FLANGE, MALE, SEAM WELD  
TYPE II LOW PROFILE

**AS1895™/5**  
SHEET 1 OF 3

**REV.  
D**

ISSUED 1985-12 REAFFIRMED 2015-01 REVISED 2021-03

FIGURE 1 - TYPICAL SECTION

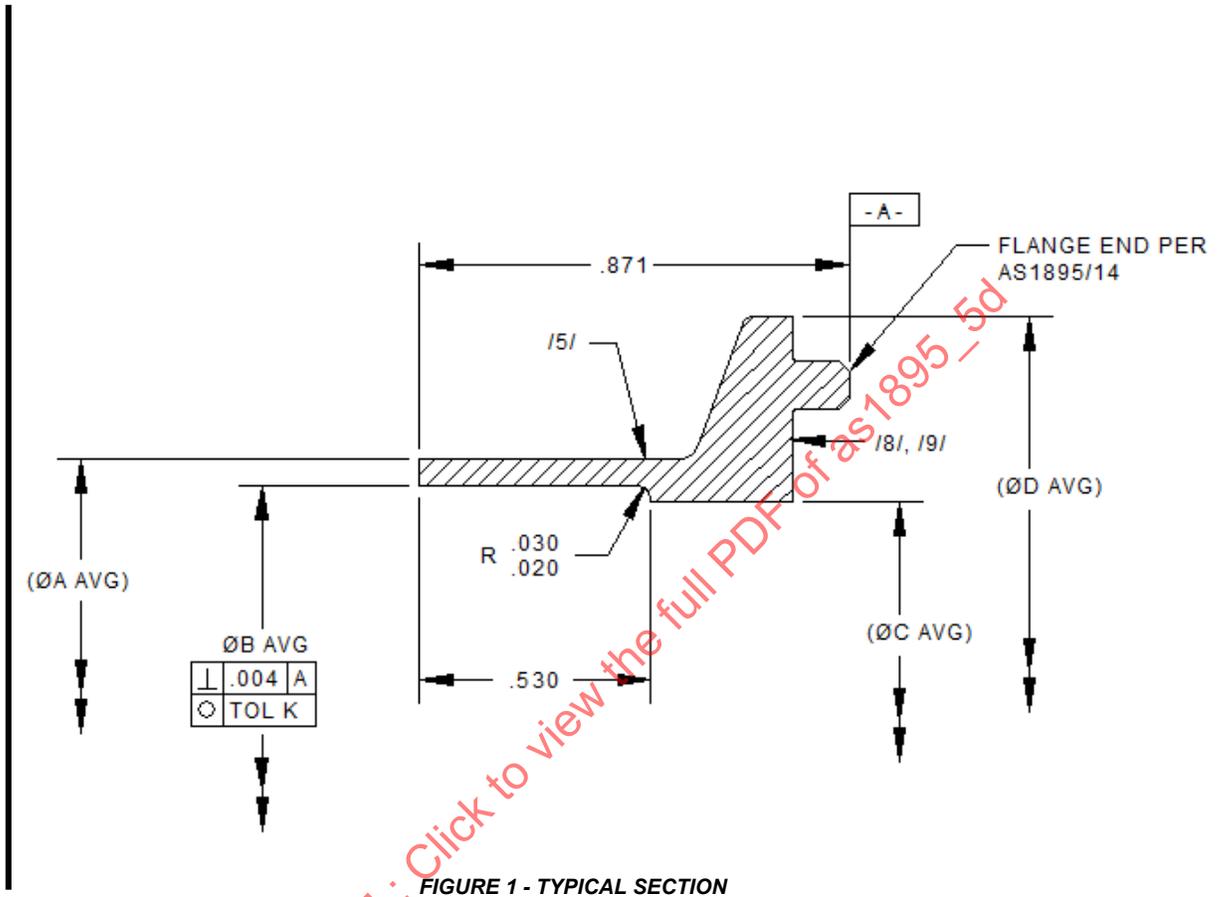
GRAPHICS REDRAWN. CIRCULARITY REQUIREMENT REMOVED FROM ØA. ØA CHANGED TO A REFERENCE DIMENSION. TABLE 1 REDRAWN TO ADD 'REF' TO DIM A, C AND D. NOTE 3 REVISED TO STATE CURRENT QML NOTE. GENERAL UPDATING OF SPECIFICATIONS BEING SPECIFIED HEREIN. CHANGE BAR NOTE REVISED. NOTE 17 ADDED.
